E4980A-01A

S E R V I C E N O T E

E4980A Precision LCR Meter 20 Hz to 2 MHz

Power supply for E4980A might be defective due to its design

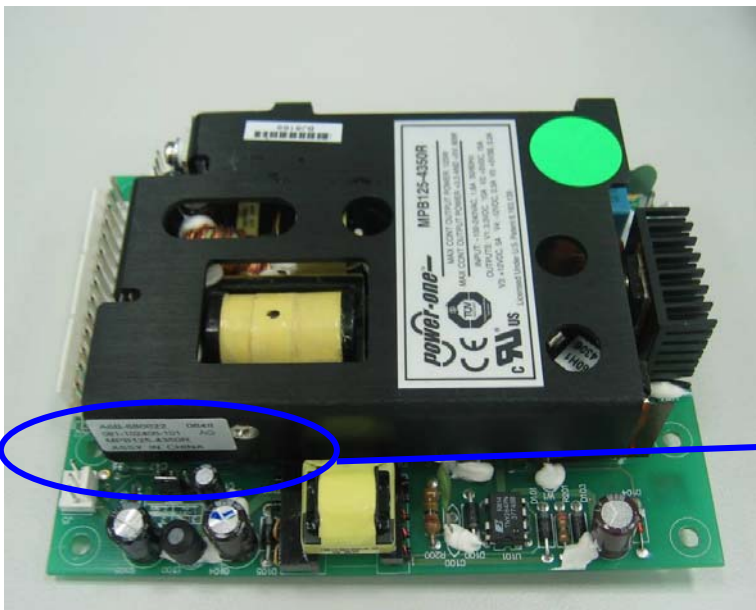
The E4980A specified above serial numbers contain the power supply that might be defective due to a problem in its design by a third company.

For MY46100102 to MY46100134, the power supply has the sticker on which “OLD PS” is written as shown in the figure below.

For MY46100889 to MY46101187 and SG46100109, the power supply has the MPN sticker with which revision number suffix is “AF”.

Replace the old power supply with the new one (p/n 0950-4918).

Use the new base plate (p/n E4980-00111) and the new power cable Assembly (p/n E4980-61601) for the new power supply.
